Development and Resource Management Department

July 6, 2016
Changes requested by Planning
Commission on July 20, 2016 in red

SUBJECT: DEVELOPMENT PERMIT APPLICATION NO. D-16-031 FOR PROPERTY
LOCATED AT 1161 EAST SHEPHERD AVENUE (APN: 403-021-03)

ARCHITECTURAL SITE PLAN
Project No. 1521
Title: A1.02
Date: 5/20/16
City of Fresno Development Department

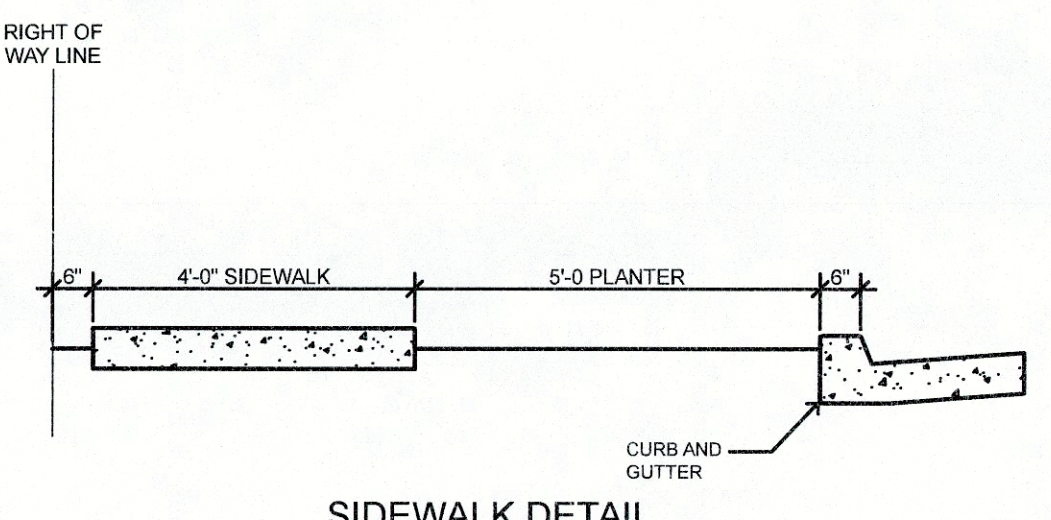
Table with 2 columns: Planner to check when completed, and 1 row: 1. Transfer all red line notes, etc., shown on Exhibits A dated May 20, 2016 and Exhibits B-1, B-2, E-1, E-2, E-3, E-4, E-5, R-1, R-2, R-3, F-1, F-2, F-3, F-4, F-5, F-6, F-7, F-8, and L dated April 5, 2016, to corrected exhibits. Submit the corrected exhibits for further review and approval. Please also review other agency/department comments and revise site plan accordingly. Transfer all comments and conditions on exhibits to the

<input type="checkbox"/>	10.	Fire hydrants shall be installed and fire access lanes constructed and maintained pursuant to comments from Fresno Fire Department dated April 25, and May 12, 2016. Show all Fire Department requirements (i.e. hydrant locations, water mains, fire flow notations, fire lane widths and lane/curb painting) on site plan prior to final site plan sign-off by Planning.
<input type="checkbox"/>	11.	Pay the required fees as stated in the memoranda from the Fresno Metropolitan Flood Control District dated April 22, 2016 prior to issuance of building permits. Provide proof of payment to the project Planner.
<input type="checkbox"/>	12.	Pay applicable development fees to the Clovis Unified School District prior to issuance of building permits.
<input type="checkbox"/>	13.	Install a 6-foot, 7 inch wall as allowed through the minor deviation process (10% increase allowed). Call out wall on corrected site plan.

Required	Table, §15-1003 for RM-1 District: Frontage Coverage = minimum 50% of area between the minimum and maximum front setback area. Lot Coverage = maximum 50% of lot. On-site Open Space = minimum 20% of lot area.
Proposed	Lot coverage of 35.4%, as shown in site plan notes. <i>As a condition of project approval - Provide frontage coverage calculation and illustrate on Site Plan.</i>

Comment	<p>Show typical dimensions of parking stalls on the Site Plan that conform to City Standards – provided.</p> <p><i>As a condition of project approval – Show 10 additional uncovered parking stalls on the Site Plan (may convert the additional covered stalls shown on site Plan).</i></p>
ON-SITE OPEN SPACE
